EVALUATION BY THE OFFICE OF NUCLEAR REACTOR REGULATION
AUXILIARY FEEDWATER SYSTEM RELIABILITY (GENERIC ISSUE NO. 124)
WITH RESPECT TO CRYSTAL RIVER GENERATING PLANT, UNIT 3

CRYSTAL RIVER, UNIT 3 - AUXILIARY FEEDWATER
SYSTEM OVERALL RELIABILITY ASSESSMENT

Figure 4 DC emergency lighting in the
ATW system room

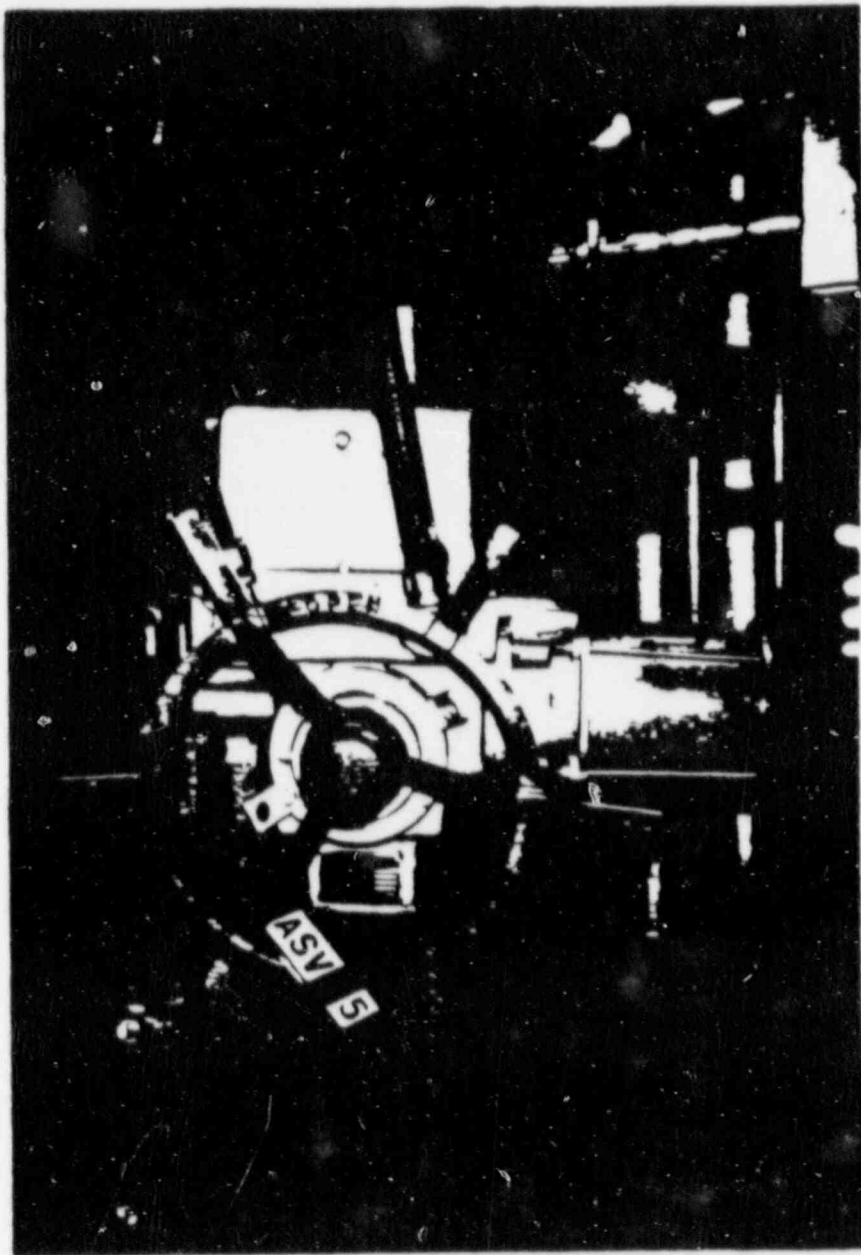
- (8) The licensee should improve the DC emergency lighting at the turbine-driven AFW pump location (Section D.5.2).
- (9) The training program for the new systems engineer position should include maintenance training or the engineer should be strongly encouraged to attend such training. The staff believes that this training will enhance the engineer's trouble-shooting and root-cause-analysis abilities (Section D.6.2).

Figure 7 AFWS Turbine Overspeed
Trip mechanism and the
Trip and Throttle Valve
(ASV-50)

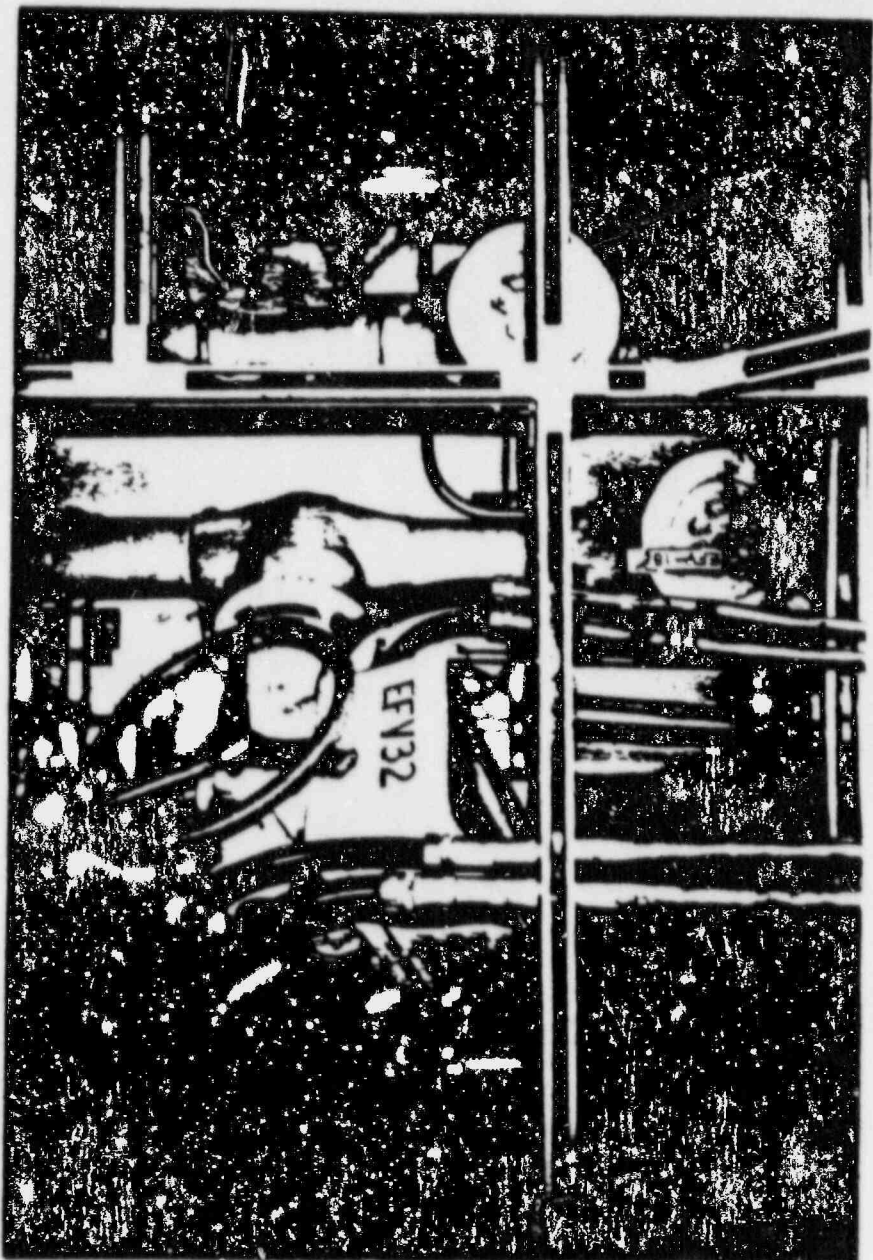
- (5) There are no standard maintenance or inspection procedures for the AFW pump turbine or the associated trip and throttle valve ASV-50. The licensee should develop standard maintenance and inspection procedures and determine an appropriate inspection frequency (Section D.2.2).

- (10) There are no standard maintenance or inspection procedures for the auxiliary feedwater pump turbine or the associated trip and throttle valve ASV-50. The licensee stated that maintenance/inspection procedures would be written in a work request on an as-needed basis. Considering the criticality of these components, the staff believes it would enhance the reliability of the turbine-driven AFW pump if the licensee inspects the turbine and valves internals on a periodic basis. Based on the staff's evaluation of other plants with similar components and frequency of use (surveillance testing and emergency actuations), the staff believes that a procedure should be developed to disassemble and inspect the components on a regular frequency.

Fig. 11 CR-3 LDMF and AFWS activations

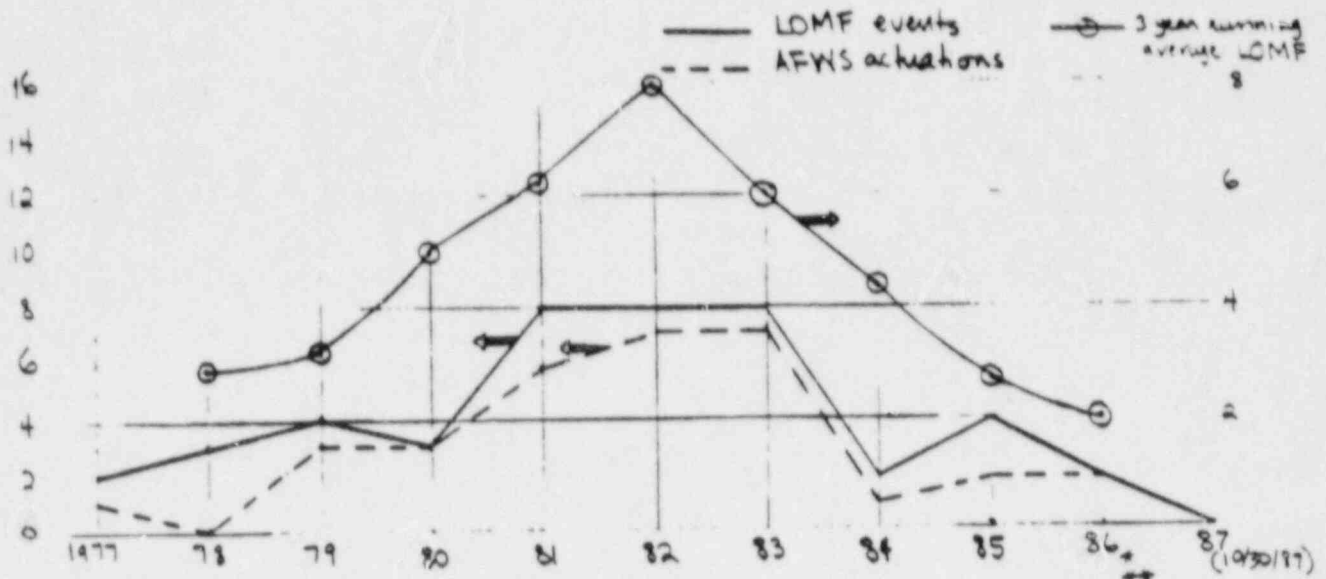
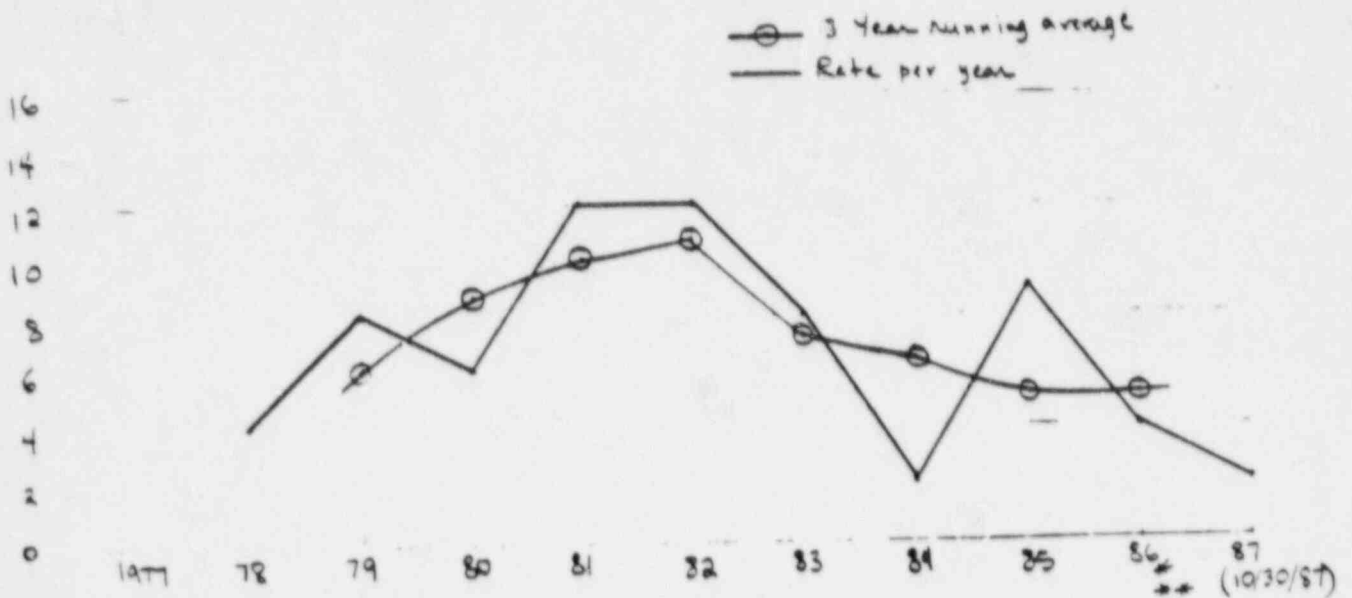
As discussed in Section D.7, CR-3's rate of unanticipated reactor scrams and loss-of-main feedwater (LOMF) events have been fairly high. In 1981, the rate of LOMF events peaked at eight LOMF events (events where one or more main feedwater pumps tripped or flow degraded), with six of these events requiring AFWS actuation. In the same year, the plant had 12 unplanned reactor trips. The number of unplanned reactor trips decreased to two in 1984 but increased to nine in 1985, as compared to an industry average of 4.3 per reactor year for that year. The average rate of LOMF events for CR-3 is 4.7 per reactor year; the industry average for such events is 2 per reactor year. The yearly rates of LOMF, AFW initiation, and automatic reactor trips are plotted on Figures 11 and 12. Also plotted are the 3-year running averages (current year, the year before, and the year after) of the LOMF and the unplanned

reactor trip rate. These figures show a trend for the rates of LOMF and reactor trips. Both peaked in 1982 and have declined since then. This may be indicative of increased licensee attention to and the effectiveness of the licensee's maintenance program.

- (10) The licensee should establish goals for decreasing the occurrence of loss of MFW events and unanticipated reactor scrams. These goals should be consistent with the B&W Owners Group Safety and Performance Improvements Program (SPIP) recommendations as accepted by the staff. The licensee should then strive to achieve these goals in a timely manner (D.7.3).
